# Intel Technical Advisory

TA-916-1

## Intel is adding another vendor to the Approved Manufacturer List (AML) for the server chassis hard disk drive (HDD) carrier

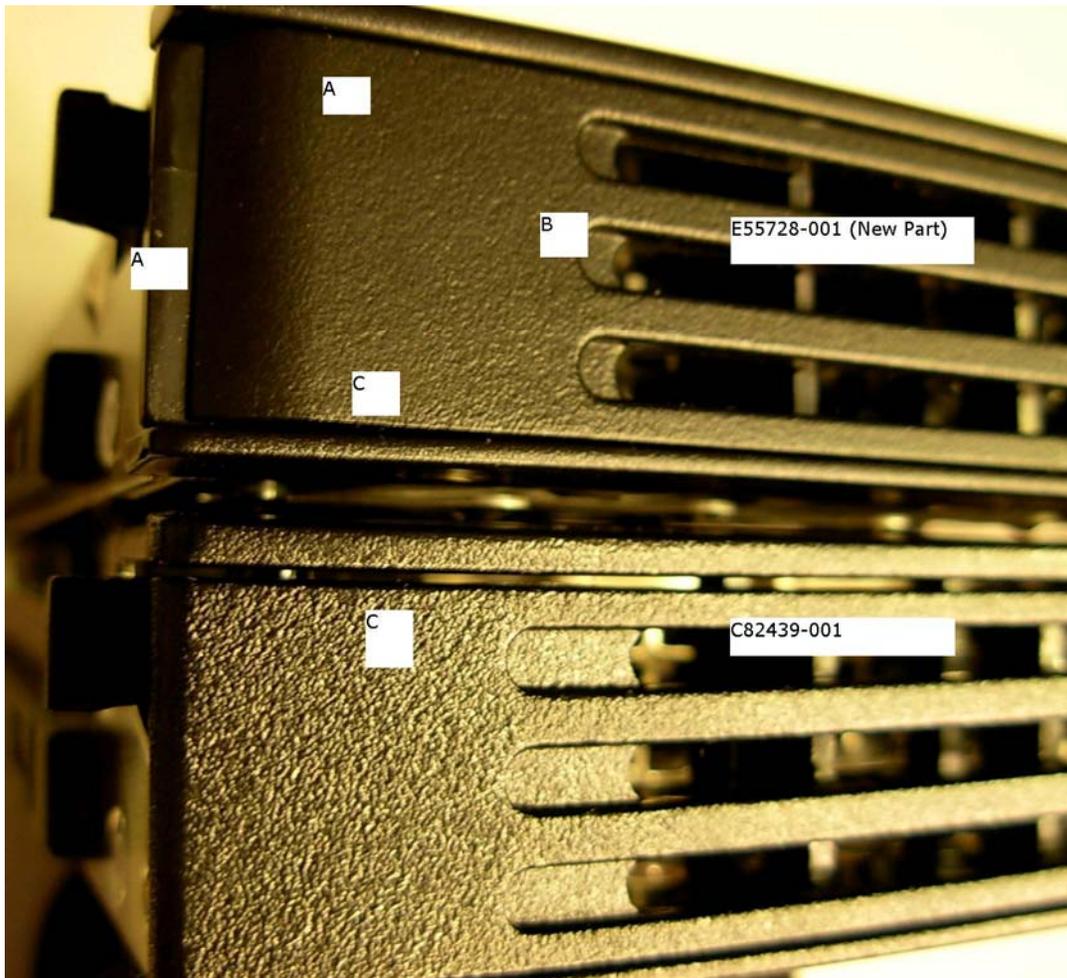
In the November 2008 timeframe this new HDD carrier may be included in the server products listed. The new HDD part number is E55728-001. It looks nearly identical to the existing C82439-001 HDD carrier. Photographs of both HDD carriers are provided below to highlight the minor differences between the existing and additional HDD carriers.

The top HDD carrier is the new carrier (E55728-001) with the changes highlighted. The new carrier includes a slightly different size/color drive bay screw. It includes the center HDD tabs on the drive baffle. These center HDD tabs are also referred to as snap features in the disposable air baffle. They have no impact to the functionality of the air baffle.

Other cosmetic differences are a slightly rounded front corner edge on the left side (A), a louvered indentation that does not extend as far to the left corner of the driver carrier (B), and a slightly smoother plastic texture on the bezel (C) as shown in the photograph below.

The top HDD carrier is the new vendor carrier as shown above. The new HDD part number is E55728-001 and looks nearly identical to the existing C82439-001 HDD carrier. The differences are outlined below.

- A. Slightly rounded left front corner edge.
- B. Louvered indentation does not extend as far to the left to retain the original size of this area for customers that add pad print customization.
- C. Bezel texture difference.
